## Appendix 1 – Correspondence between BHS and Mott Macdonald of January 2017

### 1A – Email chain ending on 18/01/2017

### C10 – Coffue Drove

Figure 1 LIDAR aerial which shows approximate area of releveling.

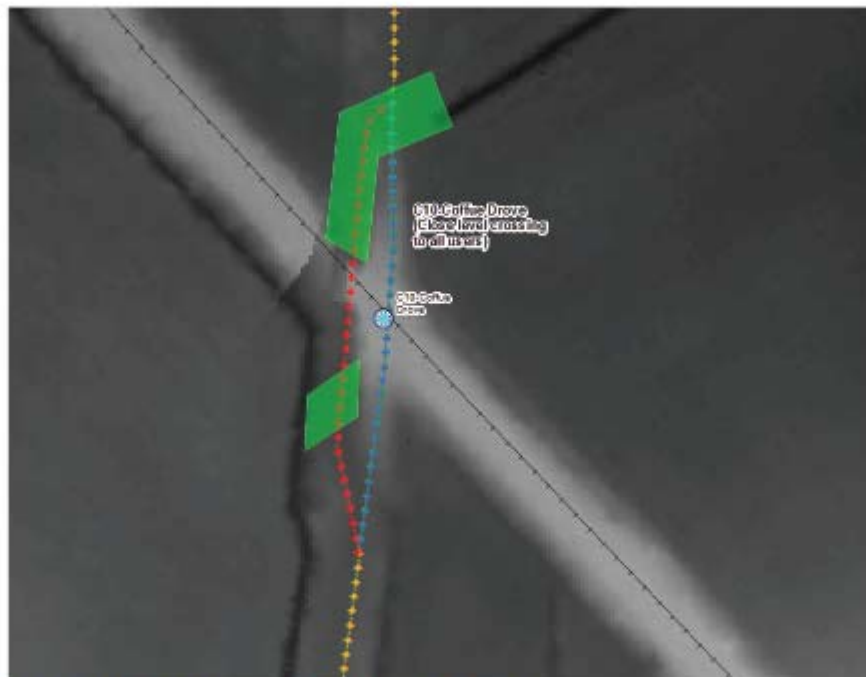
- The surface within the underpass would be sloped with a suitable cross fall. The top of the surfacing would be at least 50mm above the current ground level at the ends of the culvert to guide water outside the underpass.
- A hard paved surface within the underpass to prevent wearing from frequent usage.
- Along with the works inside the underpass additional releveling works will be required outside the underpass to allow water flow to the adjacent ditches, which are maintained by the Internal Drainage Board. See Figure 1.
